## Re: Development Application, 128 Strickland Avenue

Please find enclosed drawings and supporting documents for a development application for a proposed 5 unit development located at 128 Strickland Avenue, South Hobart. The proposed is located in the **General Residential Zone** and is within Overlay Code **116.FRE Bushfire Prone Area**. Careful consideration and initial driveway design work has ensured a safe vehicular movement to all dwellings.

Item	Description	Response
PA 3	<p>Design of access, driveway, turning area and parking spaces must satisfy either Acceptable Solutions or Performance Criteria for each clause of the Hobart Interim Planning Scheme 2015 (HIPS 2015). Documentation submitted to date does not satisfy the Acceptable Solution or provide sufficient information to support assessment under Performance Criteria.</p> <p>In order to satisfy the permitted Acceptable Solution in the Parking and Access Code (clause E.6.7.3 A1) with respect to vehicular passing areas, please demonstrate the following:</p> <ul style="list-style-type: none"> <li>Please clarify how passing bays outside Unit 2 and Unit 3 will not conflict with the proposed visitor parking spaces proposed fo

**Figure 1 Vehicle Passing Areas**

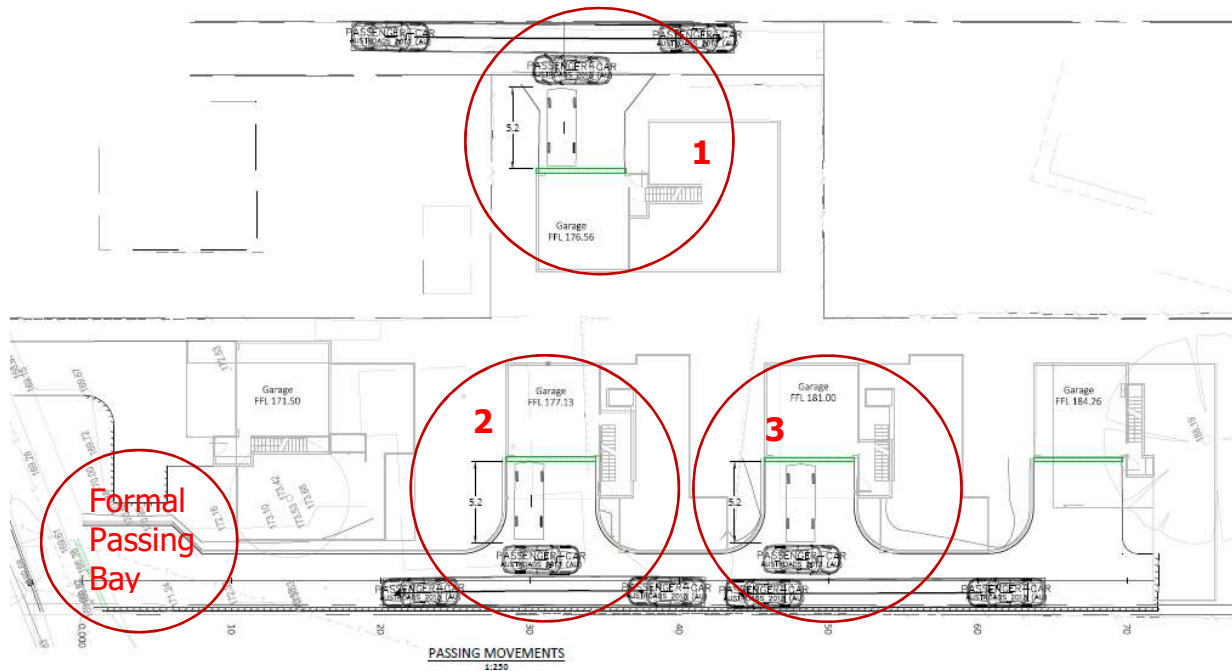
*To satisfy Hobart Interim Planning Scheme 2015 clauses E6.7.3 Acceptable Solution A1 the scaled and dimensioned design drawings must include:*

- The driveway containing passing bays 2 and 3 contains a total of 9 parking spaces (assuming 1 visitor space in front of the garages) and therefore the requirement for passing bays is triggered under E6.7.3. The available width does not meet the requirements of Acceptable Solution A1 (which requires 5.5 metres). Figure 1 demonstrates that cars travelling in opposing directions can pass each other when a car is parked in front of the garage (visitor parking).

- It is noted that at times when a car is not parked in the visitor parking spaces, that there is available width in accordance with the requirements of Acceptable Solution A1 of Clause E6.7.3 of the Planning Scheme. It is further noted that there is a lower likelihood of both visitor parking spaces being occupied at the same times as two cars are travelling in both directions along the driveway is very low. For this to occur, it would likely be due to vehicle movements in the southernmost dwelling as all spaces would be occupied in the dwellings at passing bays 2 and 3 (and hence unlikely to have any further demands).

Based on the findings above, the driveway does not fully comply with the requirements of the Acceptable Solution A1 of Clause E6.7.3 of the Planning Scheme. The Performance Criteria P1 states:

- a. Conflicts will be easily avoided due to the low speed and low volume environment. Whilst the driveway width is narrow, there is sufficient space for pedestrians, cyclists and vehicles to avoid conflict (in the case of vehicles, the use of the driveways for passing bays as documented above and shown in Figure 1).
- b. The function and use of the driveway will not have any significant detrimental impact on the flow of traffic on Strickland Avenue.
- c. The use of the driveway is exclusively residential in nature. Traffic generation is therefore relatively low during peak periods. The design of the driveway is suitable with the proposed residential use.
- d. The driveway has a straight alignment and only provides access to the proposed residential dwellings. It will therefore be easily recognisable by users and have ease of accessibility.

Based on the above findings, the driveway meets the requirements of Performance Criteria P1 of Clause E6.7.3 of the Planning Scheme.

**Figure 5 Driveway Long Section**

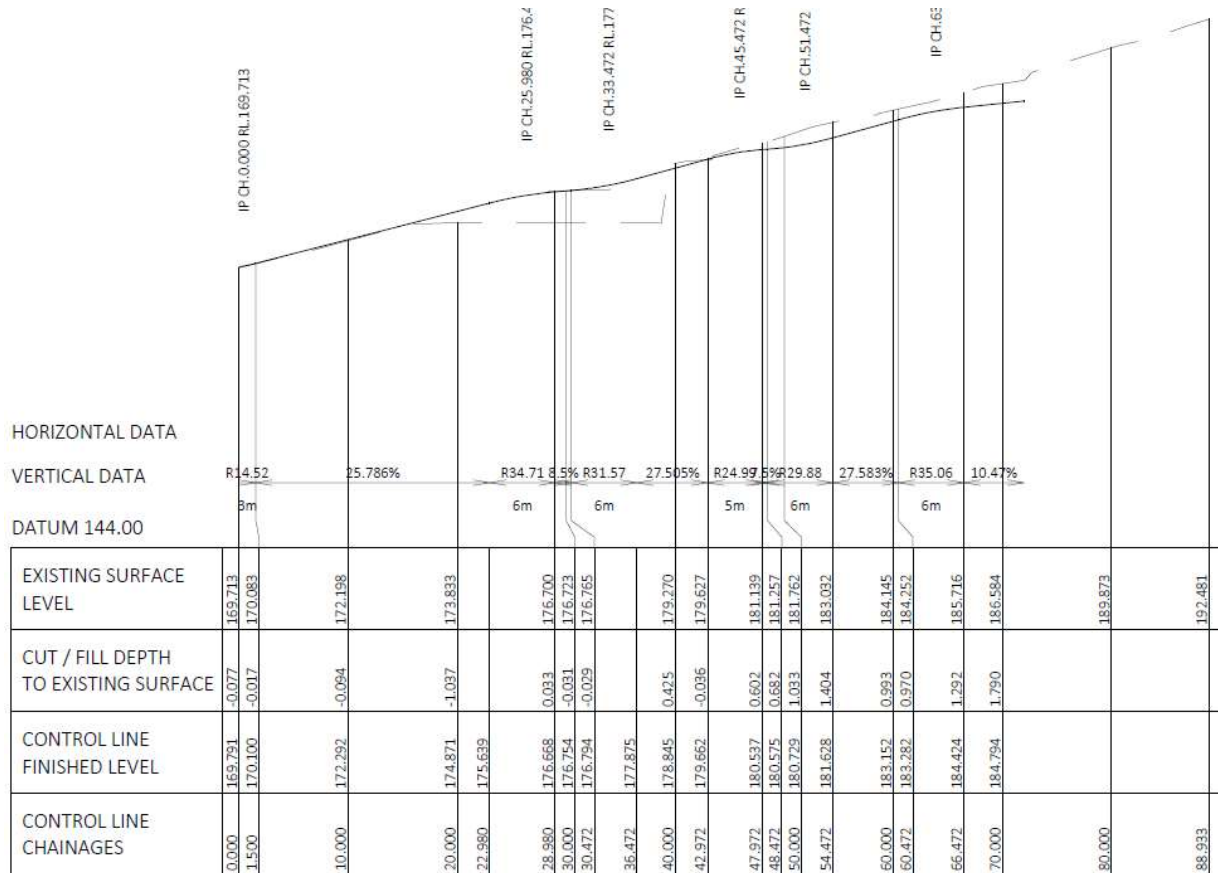
The modified driveway long section is shown in Figure 5. As noted in the TIA, the driveway exceeds 25% in several short length sections by up to 2.6%. The driveway was assessed against the Performance Criteria P1 of Clause E6.7.2 of the Planning Scheme in Section 4.6.2 of the TIA (pages 15 and 16) – this assessment is still relevant.
